Document:	Datasheet	Author /Date:	DHE / 28.12.2016
Version:	V1.1	Approved /Date:	FHA / 28.12.2016
Category:	Start Valve

Adapter Kit to Foot Start Valve VA-202180-A

Fig. 1: Adapter SAE 6 to 3/8" NPTF for In-/Outlet ports.

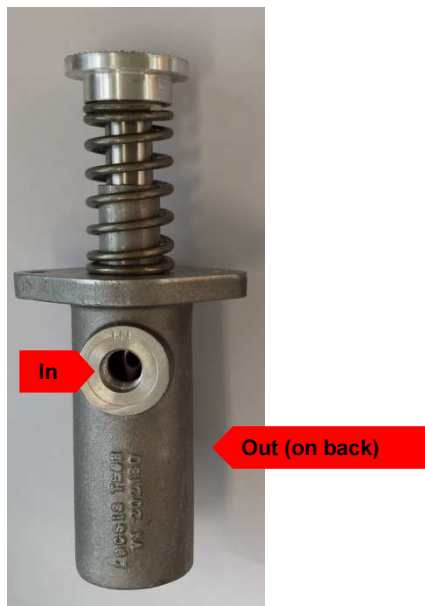
The old Foot Valve VA-202180 is no longer available and has been replaced by the new type VA-202180-A, with SAE porting.

To serve you with the right Adapter Kit, we kindly ask you to fill out the following form and to send it back to us, together with your VA order if the item is for a Retrofit application.
